Subject: 21800 Marter Road: Special Land Use Review #1
Parcel ID: 001-99-0001-000
Zoning District: CF, Community Facilities

Subject: 21800 Marter Road: Site Plan Review #1
Parcel ID: 001-99-0001-000
Zoning District: CF, Community Facilities

ASSUMPTION CHURCH SPORTS FACILITY

Drawn by :
 JWW
 Checked by :
 JAV
 Sheet Title :
 PRELIMINARY SITE PLAN

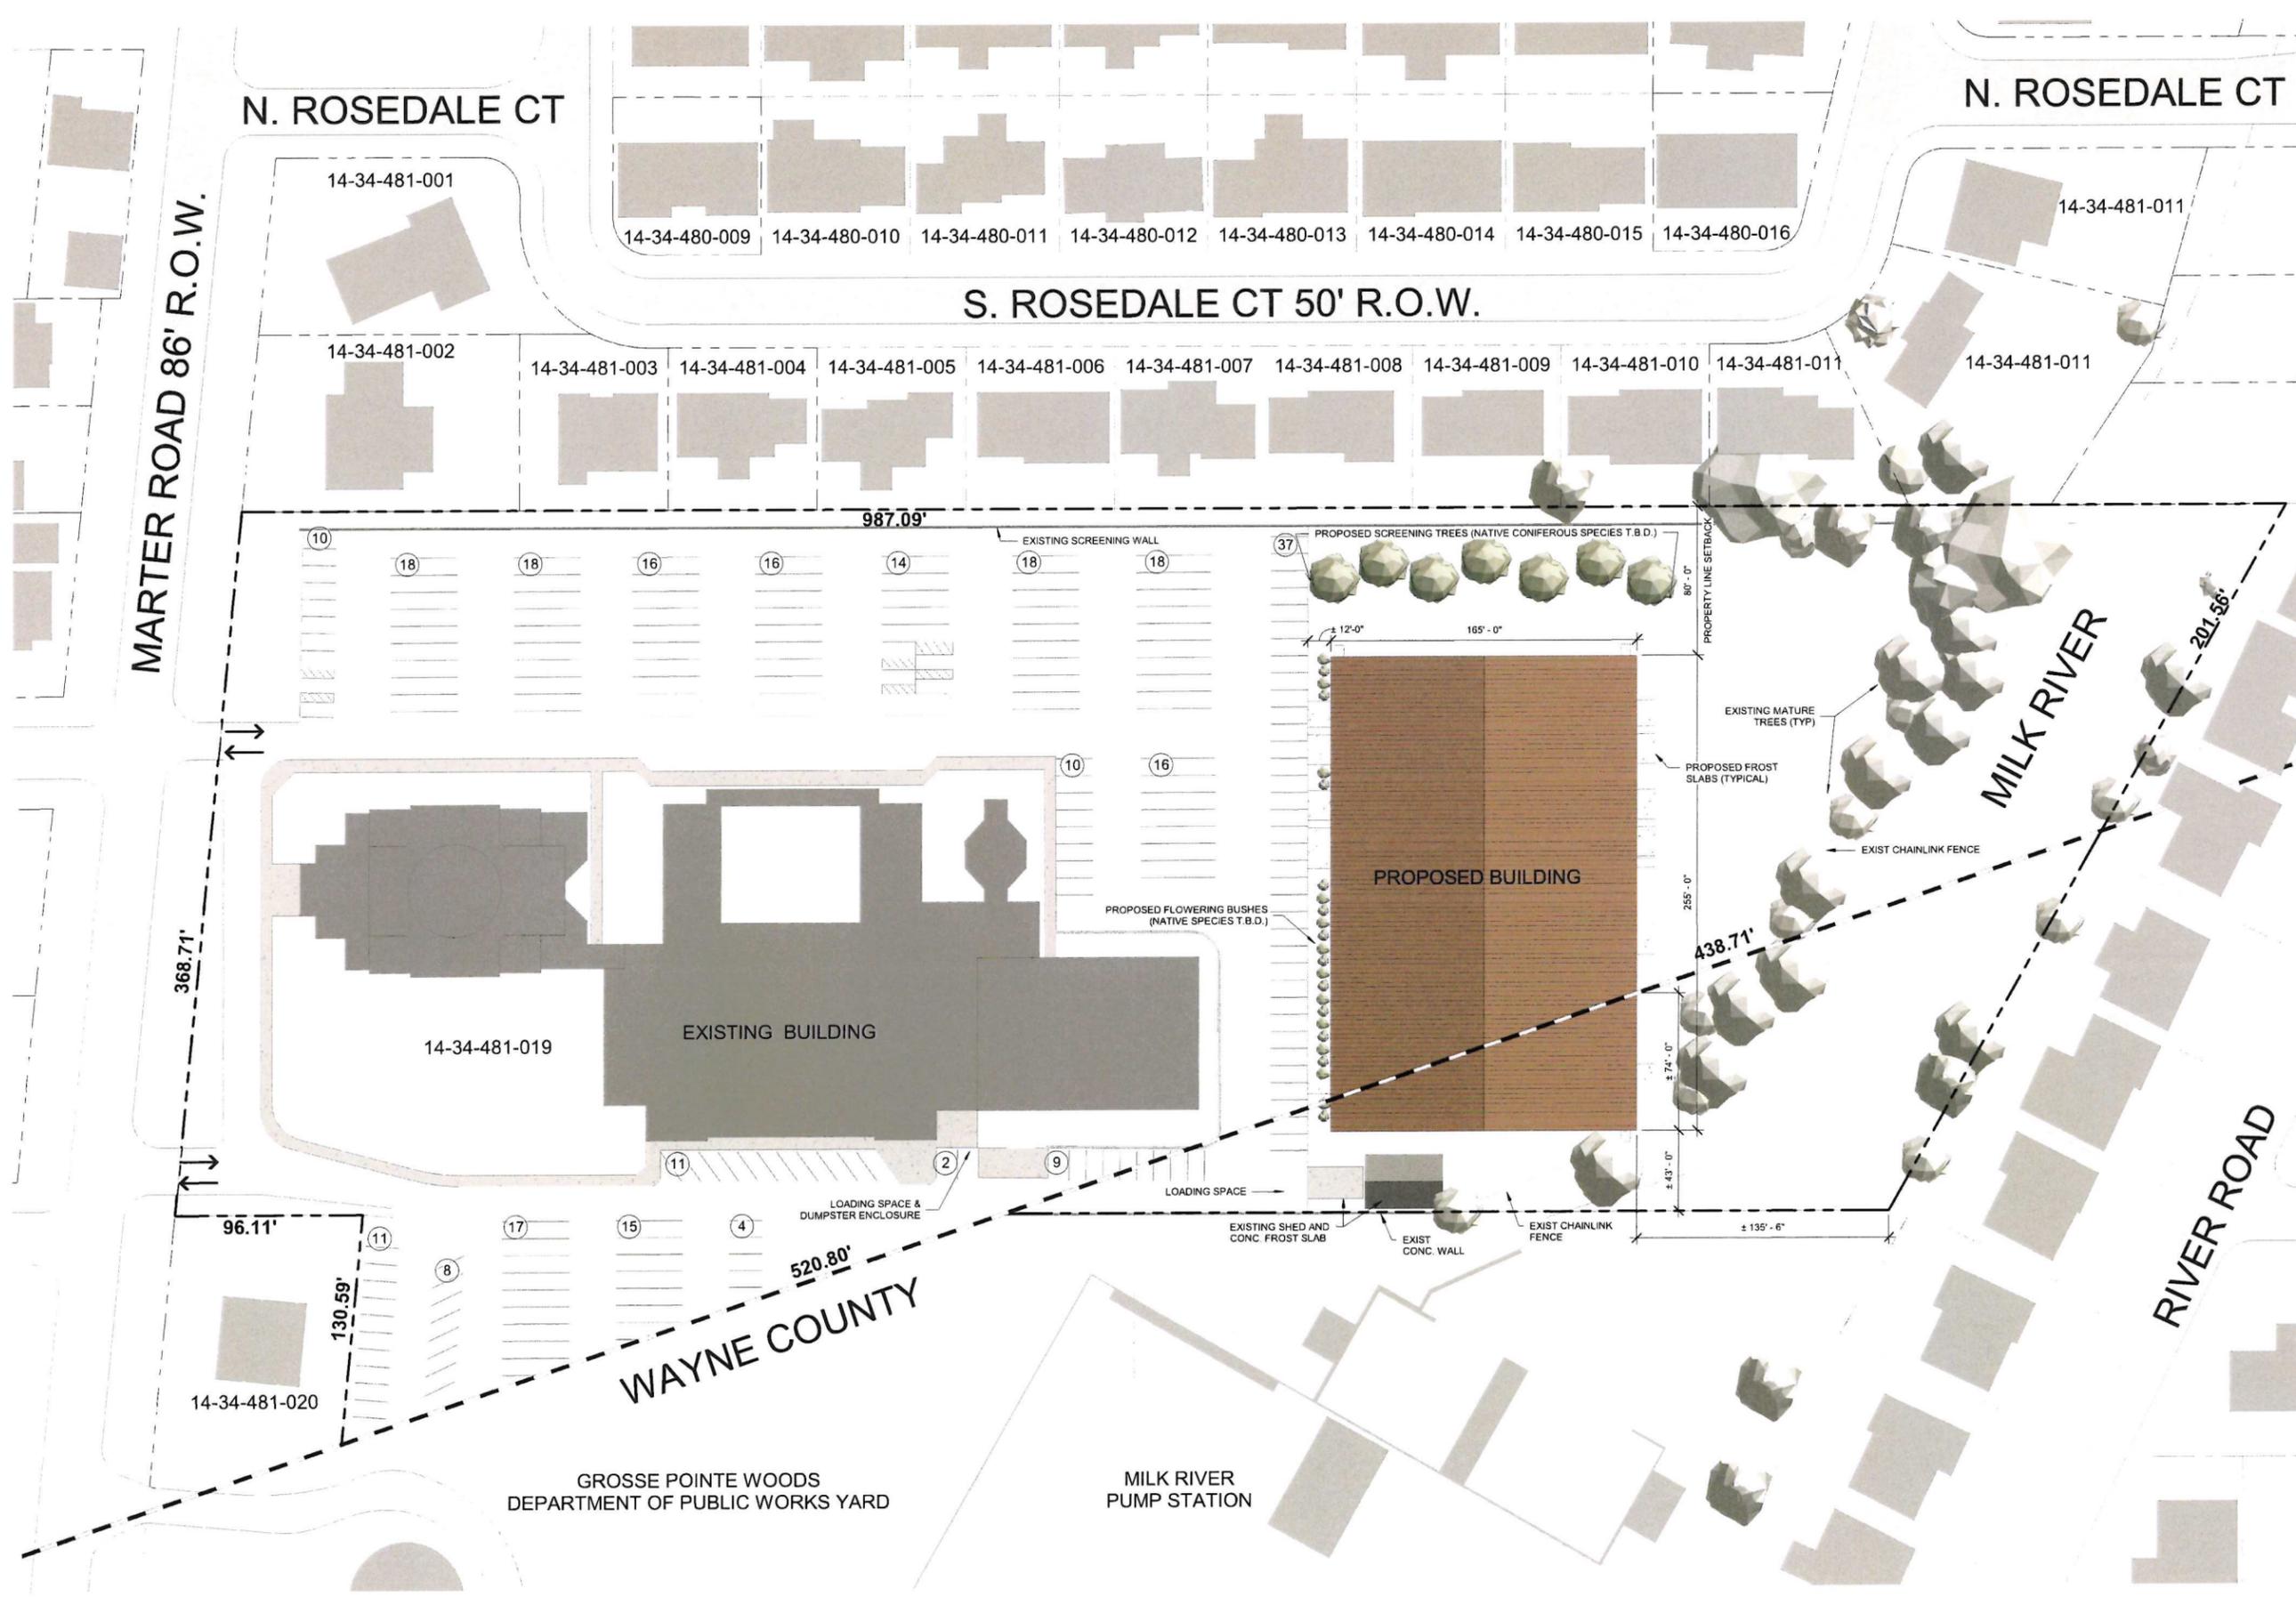
While all existing natural vegetation is to be maintained, as well as an existing concrete wall and chain link fence along the property lines, additional screening provided by evergreens should be planted to the south of the proposed building.

To achieve a balance of desirable aesthetics, greater landscaping along the southeast corner of the building is recommended: specifically, the addition of eight (8) evergreen trees in this area to provide additional screening.

The existing vegetation and buffering provided by the Milk River would be well complimented by additional trees to minimize building visibility from adjacent residential uses (those across the Milk River).

1. The Commission finds the proposed façade acceptable.
2. Additional screening is provided on the southeastern side of the proposed facility with a minimum of eight (8) evergreen trees to further obscure the building from adjacent residential properties. The species type and final location must be detailed on a revised site plan, for administrative review.
3. Special Land Use approval is granted.

Drawn by :
JWW
Checked by :
JAV
Sheet Title :
EXTERIOR ELEVATIONS

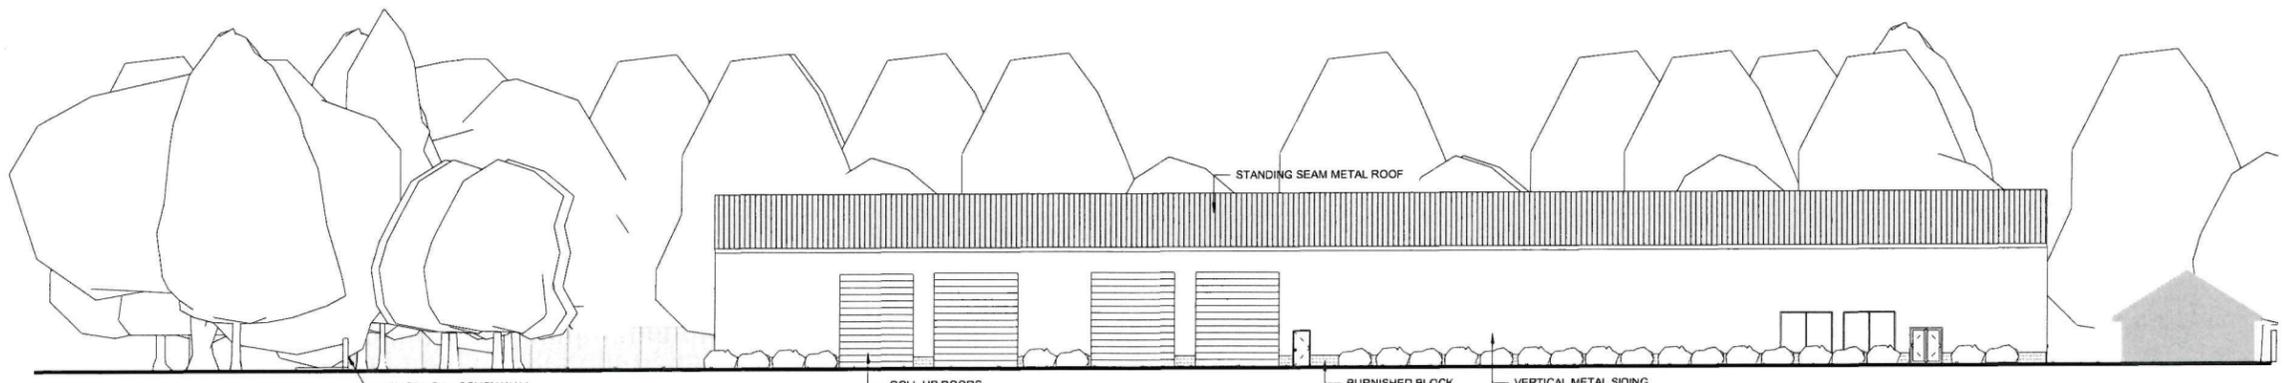
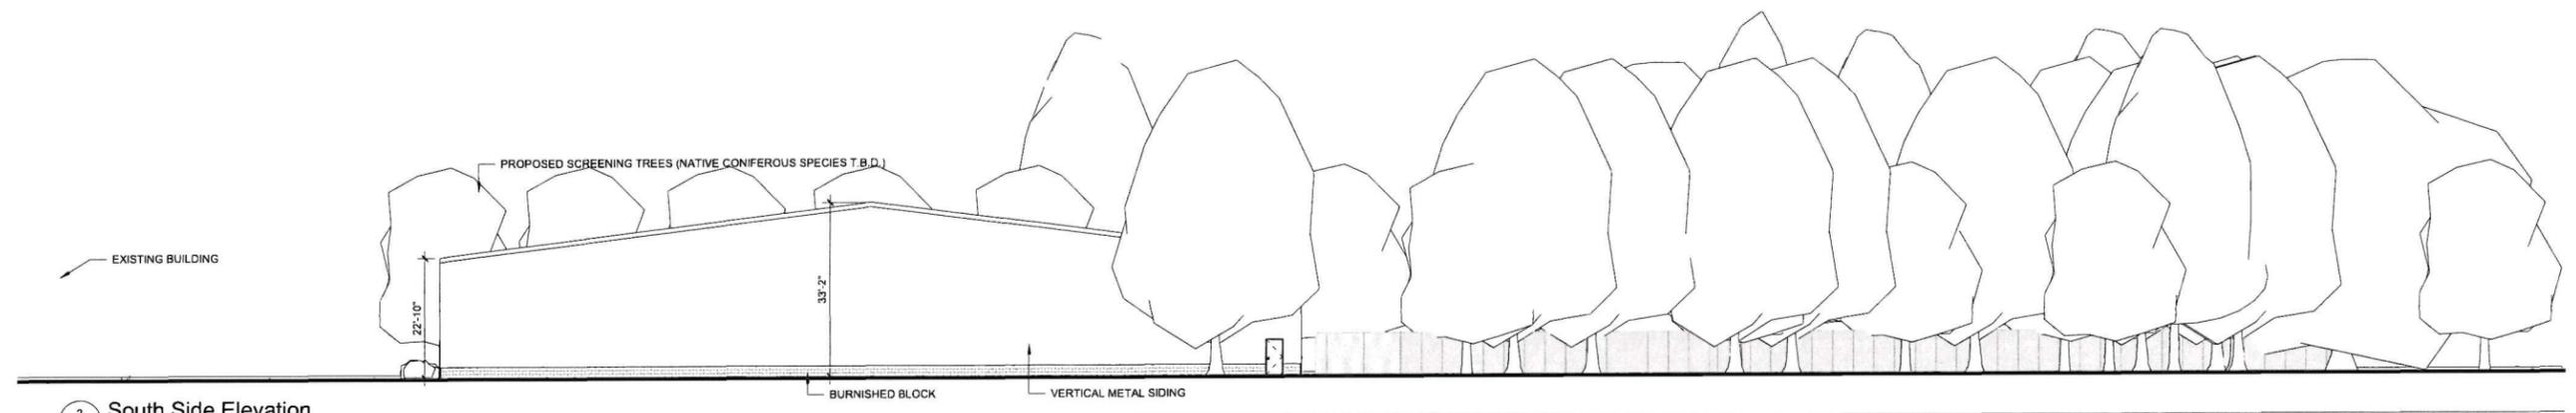
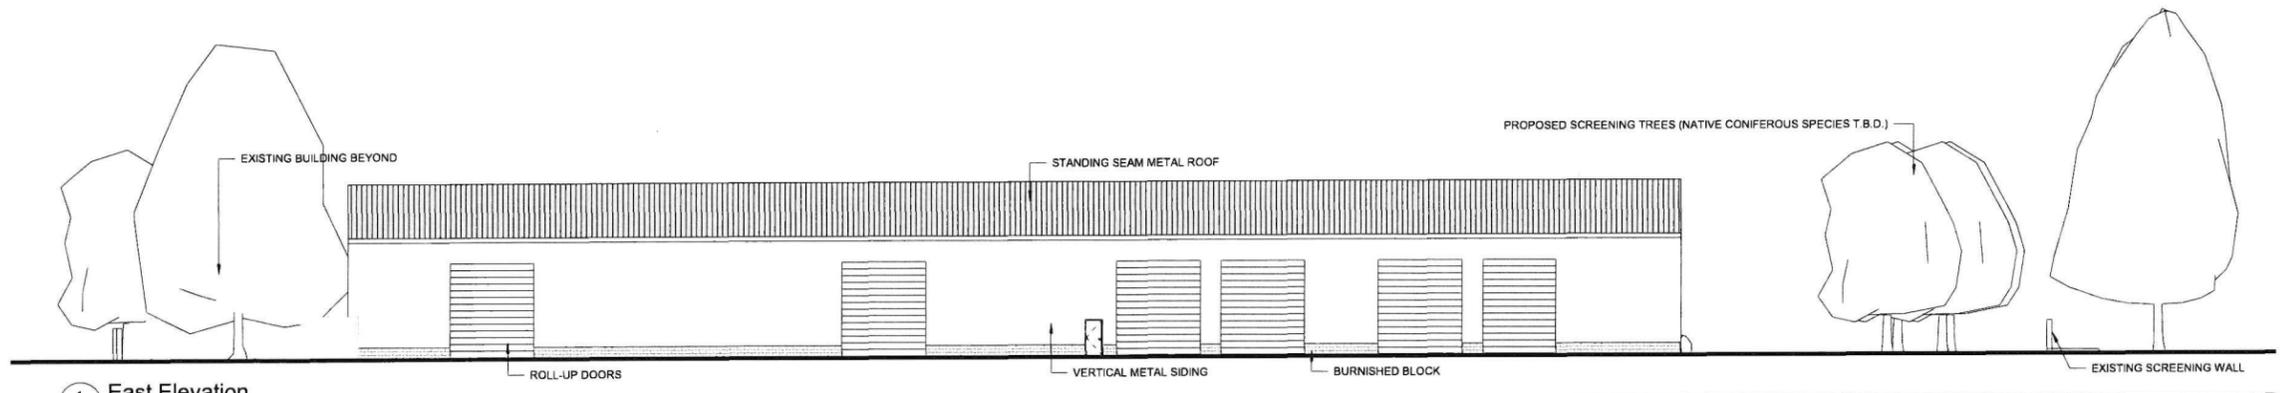
The building is proposed to consist primarily of light tan, vertical metal siding, with burnished block 2' skirting around the entirety of the facility to create a uniform appearance. There are minimal points of architectural interest, although there are four roll-up doors that break up the west building façade, and six roll-up doors on the east façade (all portions of the building located in St. Clair Shores).

The design of the building deviates from the City's traditional design standards; however, this is an institutional, accessory recreational use that is primarily located in St. Clair Shores and has complied with their ordinance requirements.

The impacted building footprint (located within Grosse Pointe Woods) is only 7,488 square feet (less than 18% of the total building footprint). Due to this minimal intrusion, and the natural vegetative barrier that already exists along the Milk River, it is recommended that the proposed building façade is approved as presented.
